IN THE MATTER OF THE
APPLICATION FOR SITE
CERTIFICATE FOR THE YELLOW ROSEBUSH
ENERGY CENTER

**INTERVENOR ALEXANDERSON'S EXCEPTIONS
TO PROPOSED ORDER ON MOTIONS FOR
SUMMARY DETERMINATION**

OAH Case No. 2024-ABC-06692

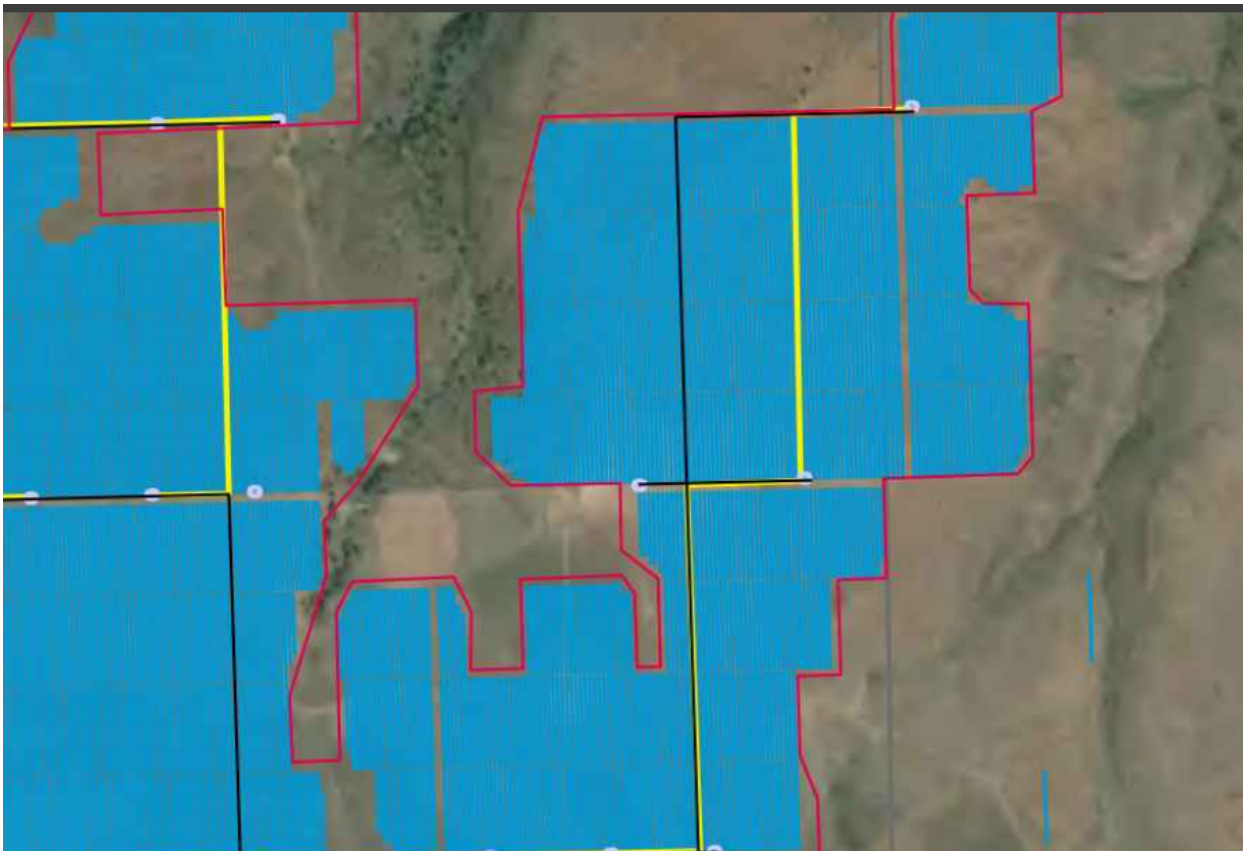
An applicant cannot prevail on MSD if it failed to account for habitat damage. Simply presuming such issues were all taken care of in closed door unidentified, untranscribed meetings with a staff persons is not enough even if Intervenor had not pointed to evidence of outside the fence degradation. There is no evidence the ODFW biologist was made aware of facts not submitted in the application or other writings. Intervenor has the procedural right to challenge an incomplete or inaccurate accounting.. Moreover, it is indisputable that the mitigation acreage does not include any acres outside the fence.

The Council determines whether the energy facility can be designed, constructed, and operated consistent with ODFW mitigation rules. To meet this standard, the rules require the applicant to conduct site-specific studies to characterize the fish and wildlife habitat **"at the site and nearby,"** i.e. explicitly requiring an inventory of off-site habitat degradation.

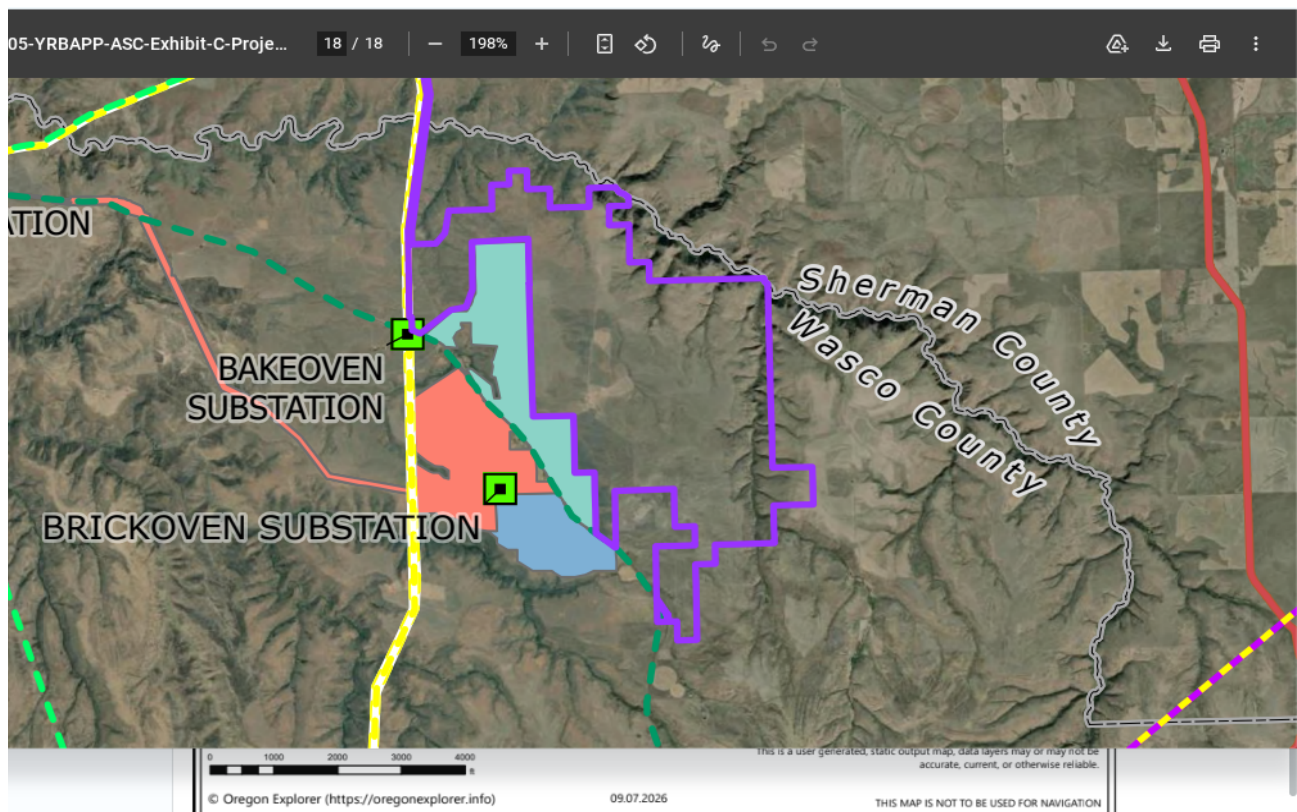
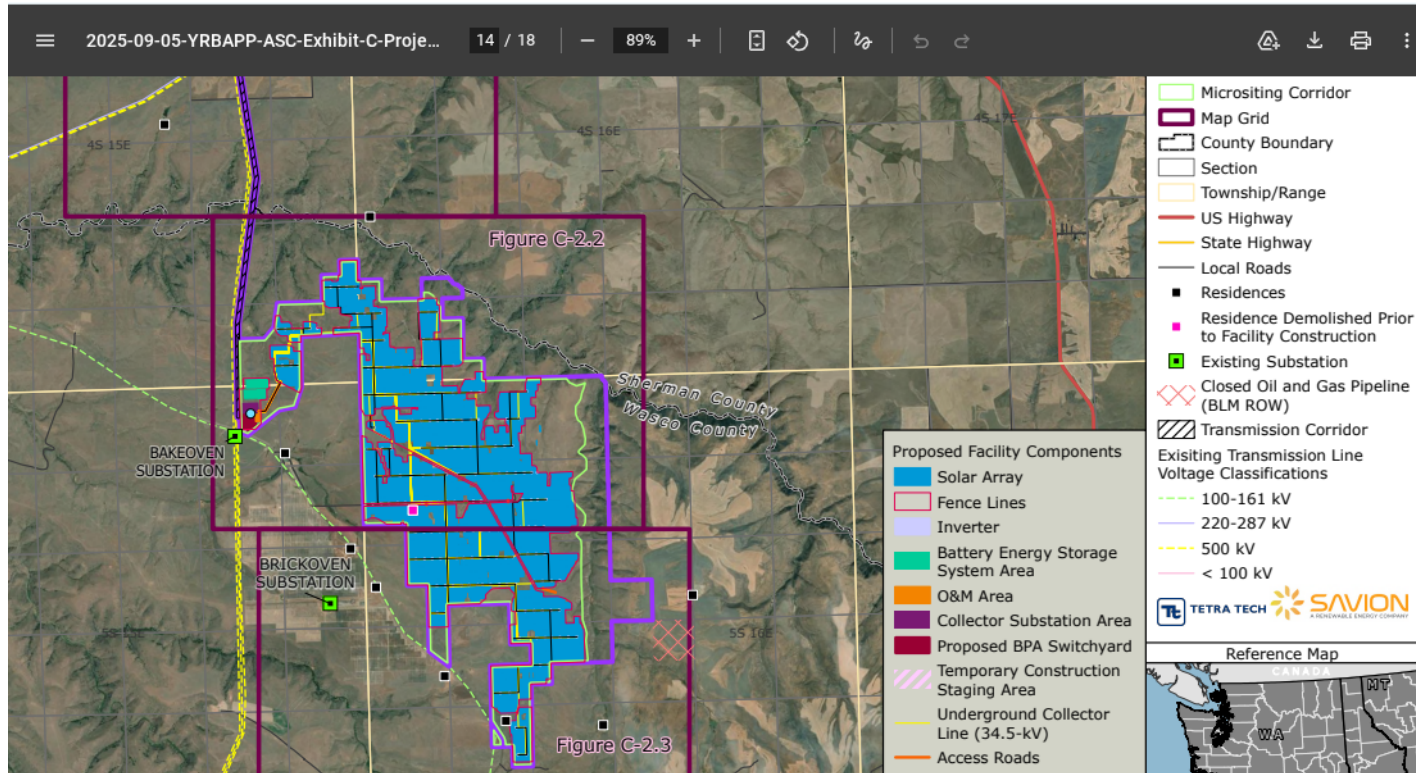
Intervenor raised the issue: “What are the cumulative effects considering the adjacent Bakeoven projects are already evicting the deer?” Alexanderson Comments last page, second to last paragraph. This issue is material because the project was sited to tightly wrap around the three approved Bakeoven projects, leaving no path between or through any of four projects except along Bakeoven Road.⁸ Common sense recognizes increased risk to deer if they are given only a public right of way to pass through. Vehicle collisions are a significant cause of deer mortality identified in the MDMP and Exhibit P. This hole in the case is an uninventoried uncompensated outside-the-fence habitat spoliation that precludes summary determination..

This shows the wrap leaving Bakeoven Road as the only throughway. The project boundary is purple. The YR fence line can be seen in the next image:

This view omits the Bakeoven projects and shows the fence line. For deer to go around they will have to circumnavigate all four projects. To go through they will only have Bakeoven Road.

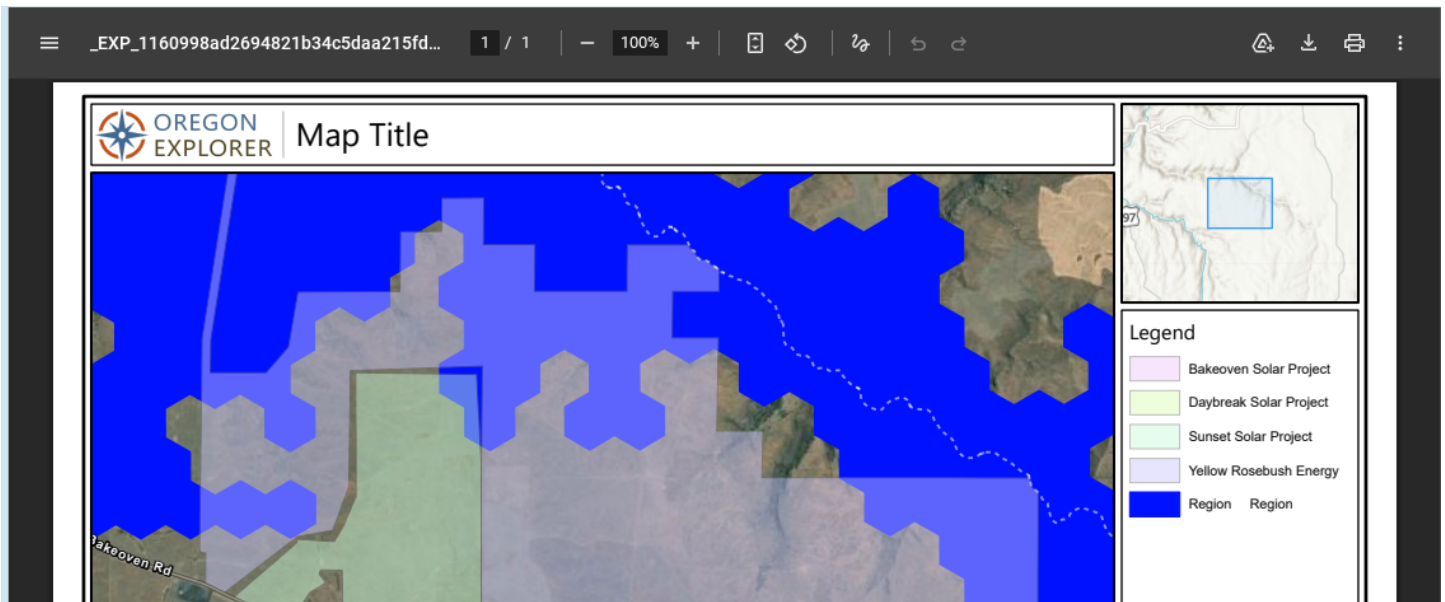
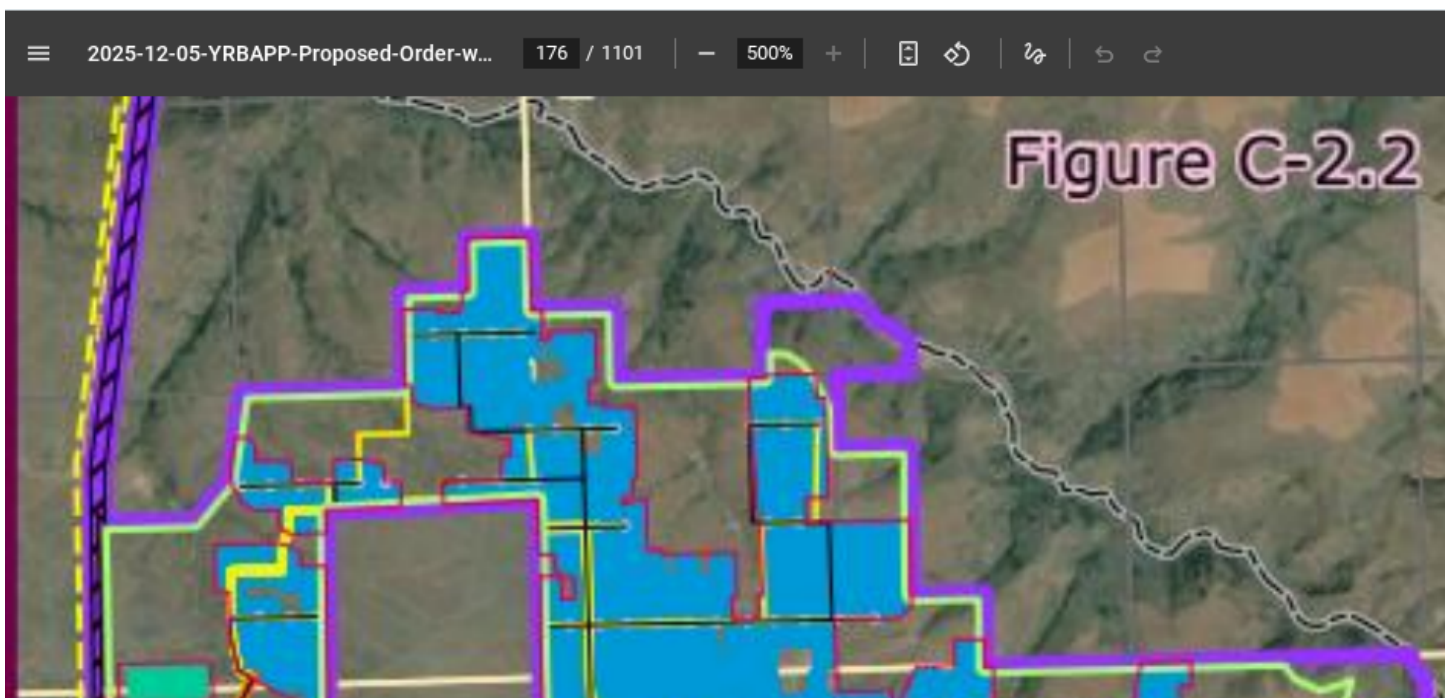
Dark blue is PWCA outside the project boundaries. Green is the Sunset (Bakeoven) approved project. The light blue is where the project boundaries include PWCA hexagons. For illustration only notice the NE corner of the green project and the light blue hexagons in the YR project adjacent to the east and north. Compare to the solar arrays below.

Here, the green project is shown as an empty square with YR's red fences. Blue denotes the YR arrays. Plainly some arrays and fences are planned to be installed in PWCA. No avoidance consideration is in the record of alternatives required by the Rule including "not taking a certain development action or parts of that action." OAR 635-417-0005(16)(a). Note also the dead end predator and fire trap just to the east.
